**TECH-20005**

**17.06.2020**

Proposal for modification of the Uniform Technical Prescription concerning freight wagons (UTP WAG)

**FREIGHT WAGONS**

*Fig. B.2*

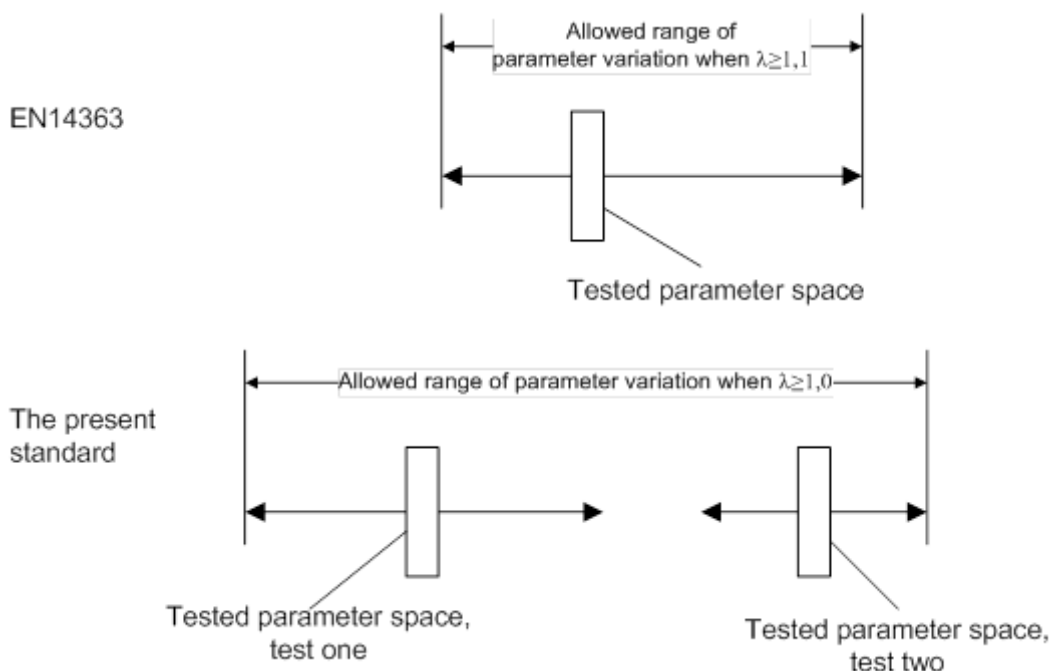
~~Following successful testing the acceptable parameter variation range is given by the range between the nominal tested parameters extended as illustrated in figure B.2.~~

~~It is permitted to perform only one test and by doing so only validating the running gear for a limited range.~~

Following successful testing in accordance with Appendix B section 2.1 the acceptable parameter variation range for dispensation from on-track tests is given by the range between the nominal tested parameters of the running gear and the extended range as illustrated in figure B.2 and specified in tables B.4 and B.5.

Figure 3H.1

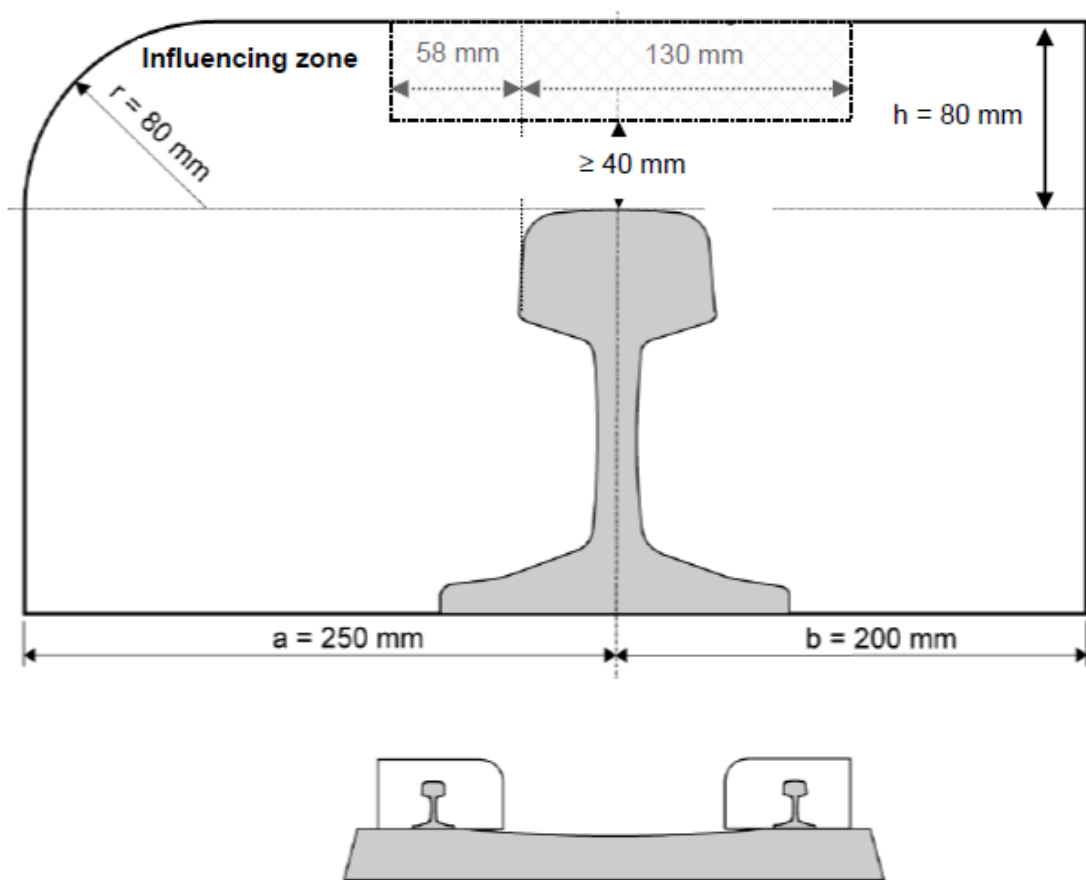
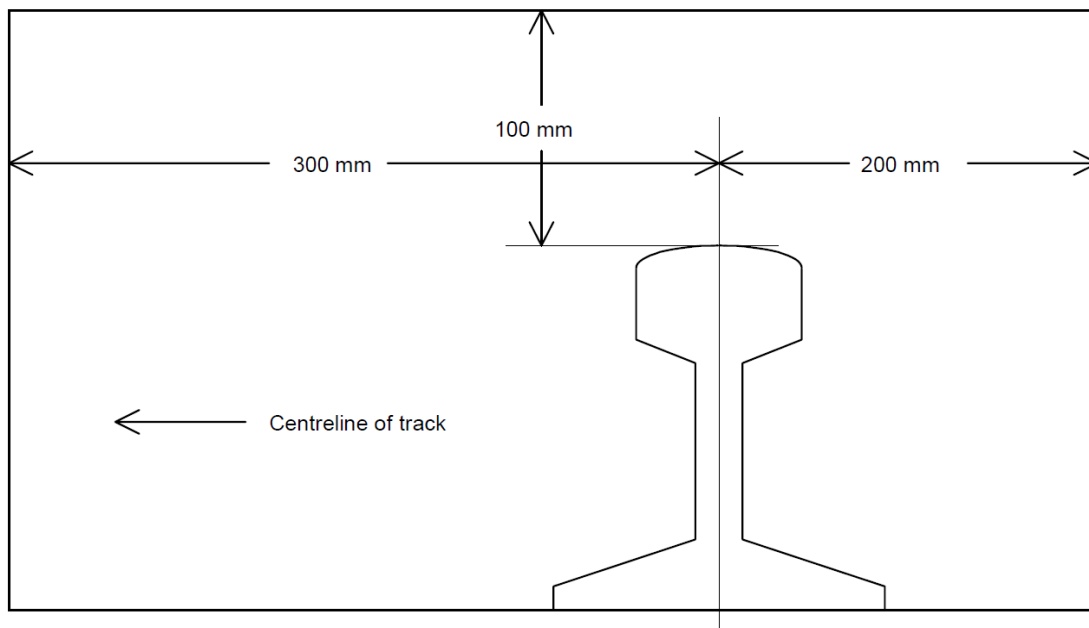
- ~~For freight wagons: only wheels and their parts (gearboxes, brake parts, sanding tube) or non-ferromagnetic and non-inductive components are mounted in the sensitive area of Fig. 3.~~

- Only wheels and their parts (gearboxes, brake parts, etc.) or non-ferromagnetic and non-inductive components shall be mounted in the area defined in figure 3H.1.

*Figure 4: Shunter's step*

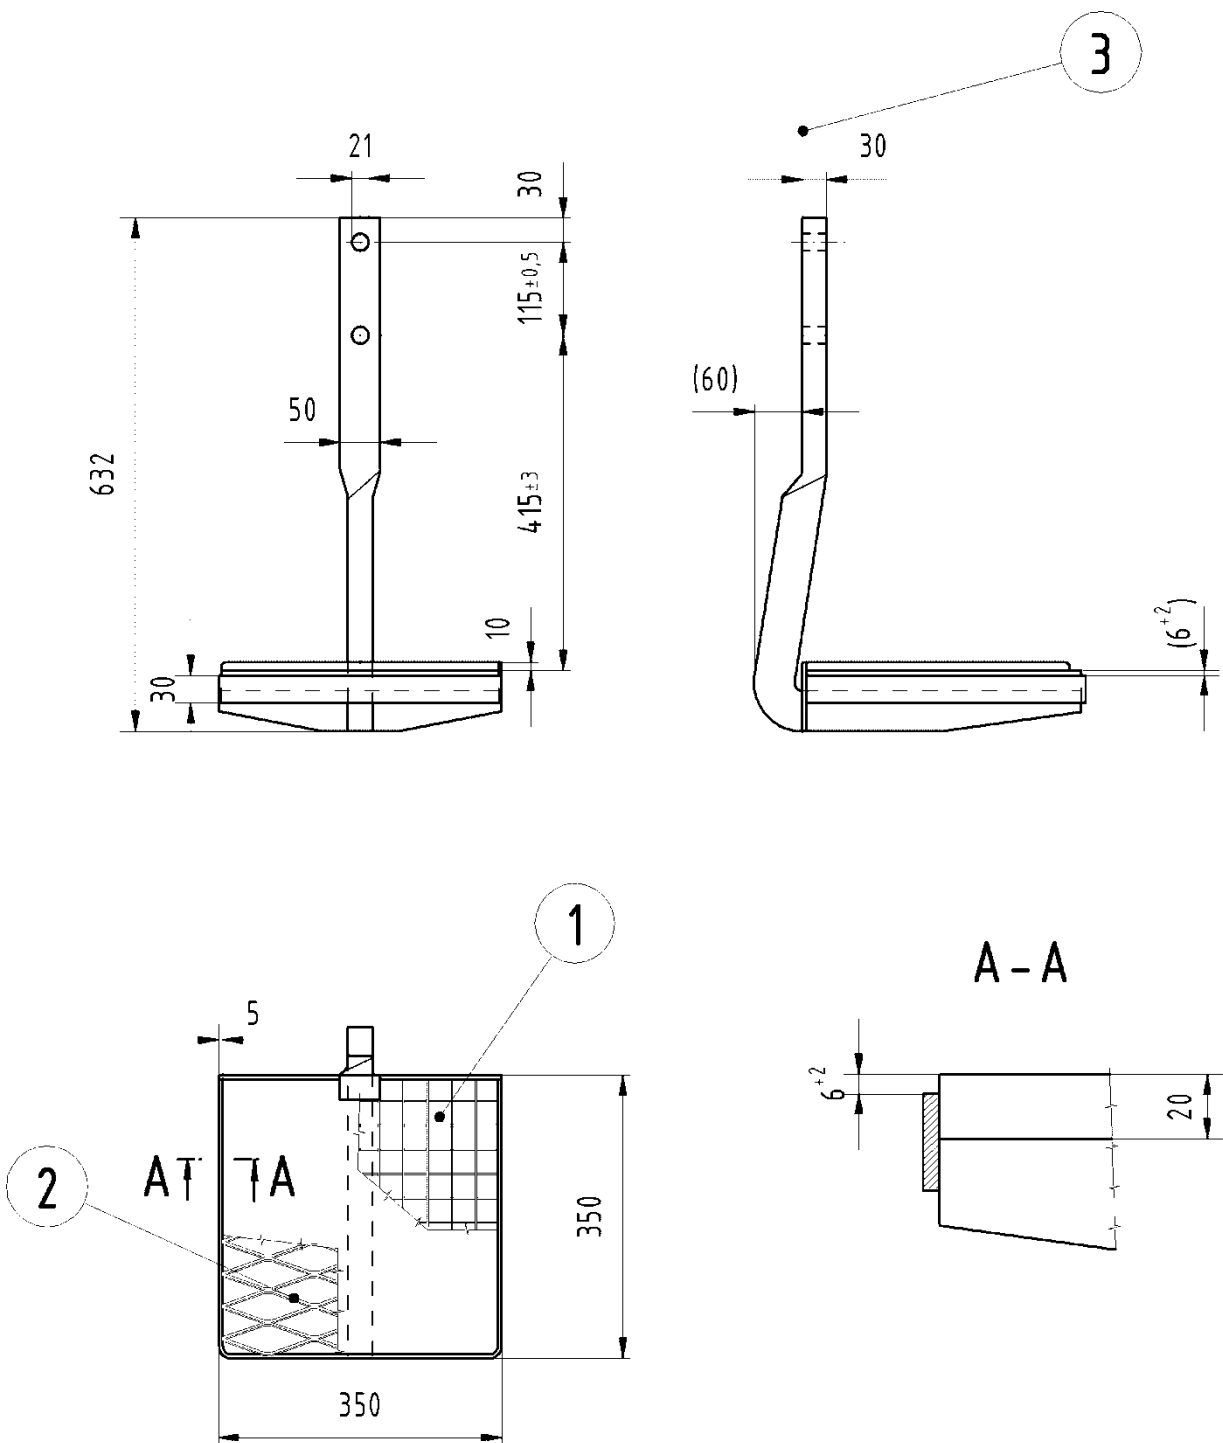
~~The minimum requirements concerning slip resistance deemed to be complied with if the grating in accordance with figure 4 is used or if the following requirements are fulfilled:~~

- ~~• The free space above the shunter's steps shall be as set out in figure 6 with the exception concerning the handrail specified in figure 5.~~
  - ~~• The dimensions of the shunter's step shall be in accordance with figure 4. For specific operation the size of the footstep can be reduced from 350 mm width and 350 mm length to 270 mm width and 225 mm length.~~

- ~~• Cold forming for shunter's steps support is not allowed.~~
  - ~~• The grating shall be according to figure 4.~~

Figure 5: Shunter's stand

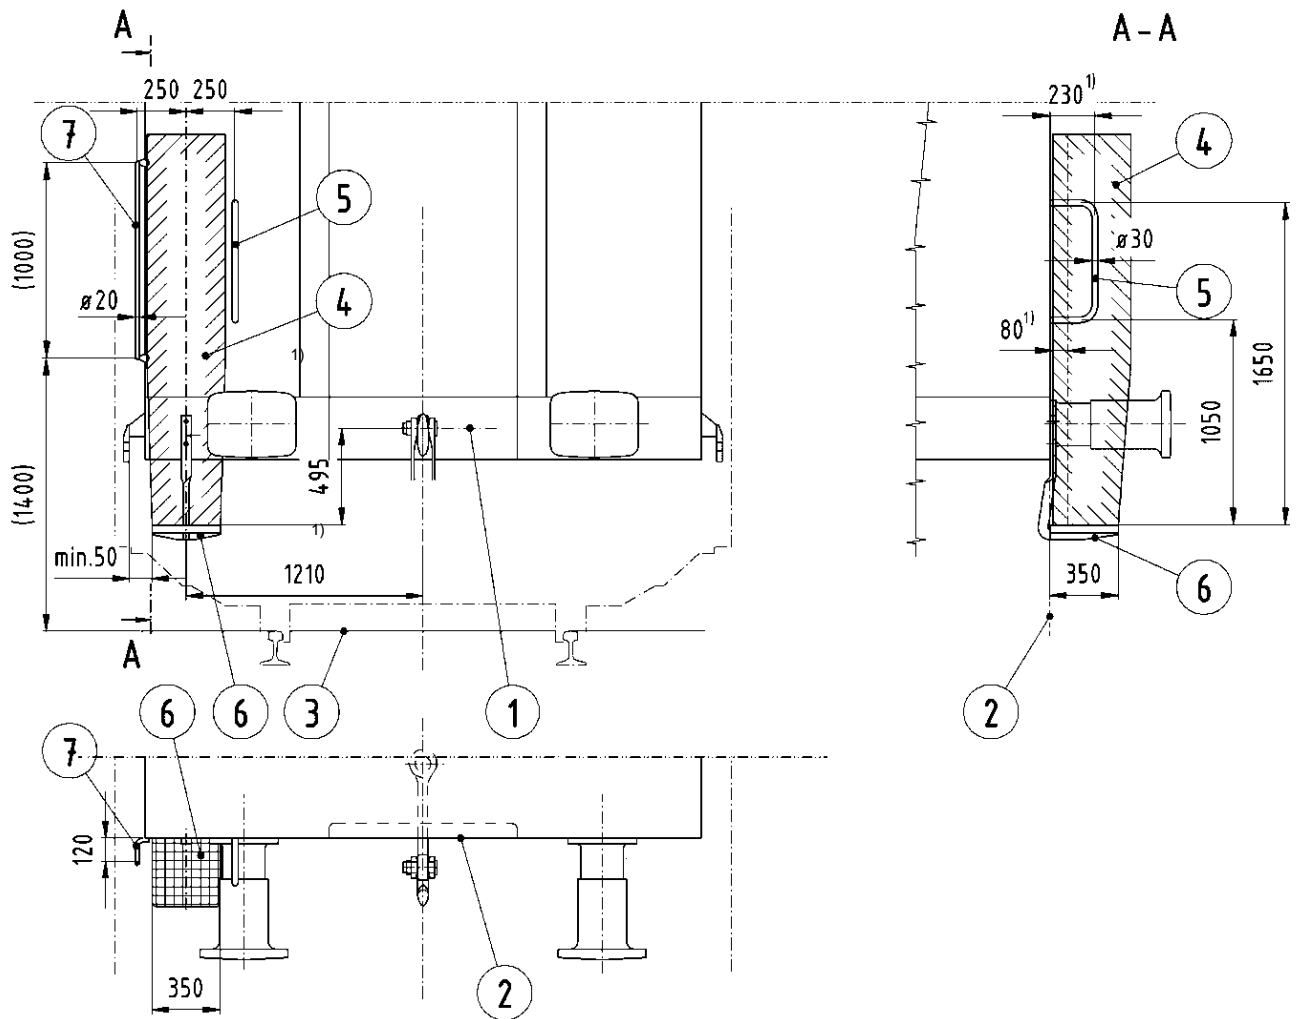
- footstep
- ~~• The shunter's steps shall be at least 150 mm from a vertical plane at the end of the fully compressed buffers (see figure 3).~~
  - ~~• The shunter's steps and handrails shall be placed as set out in figure 5.~~

*Figure 7: Positions of shunter handrails*

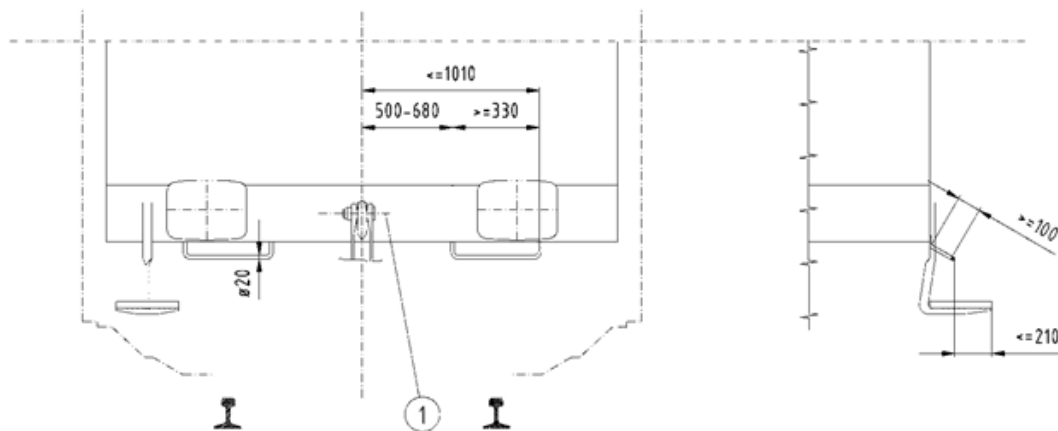
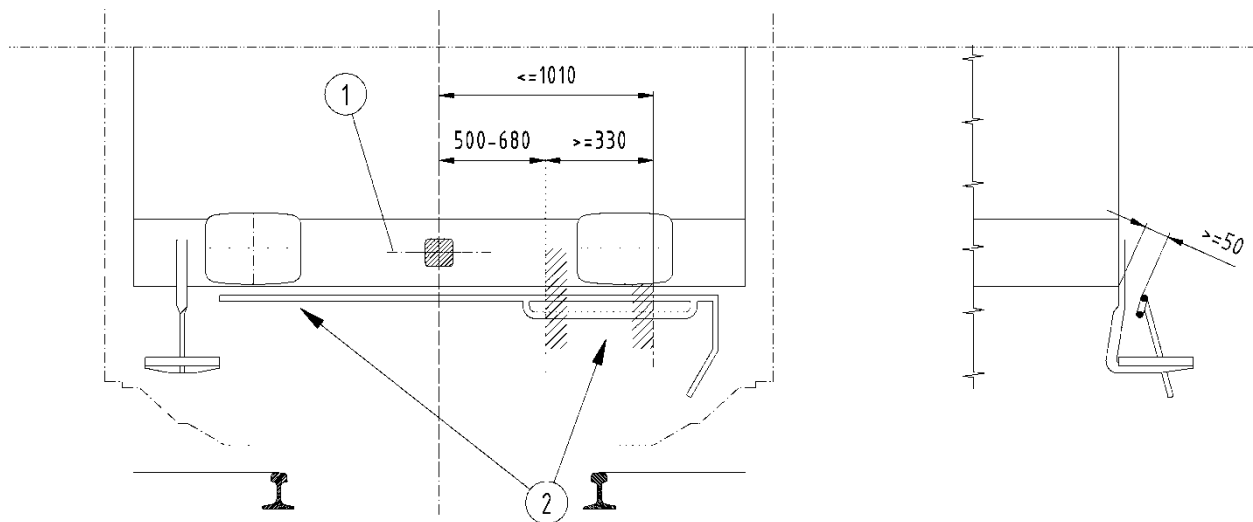
~~Furthermore, there shall be a handrail under each buffer (shunter's handrail) of the unit which shall be as specified in figures 7 and 8.~~
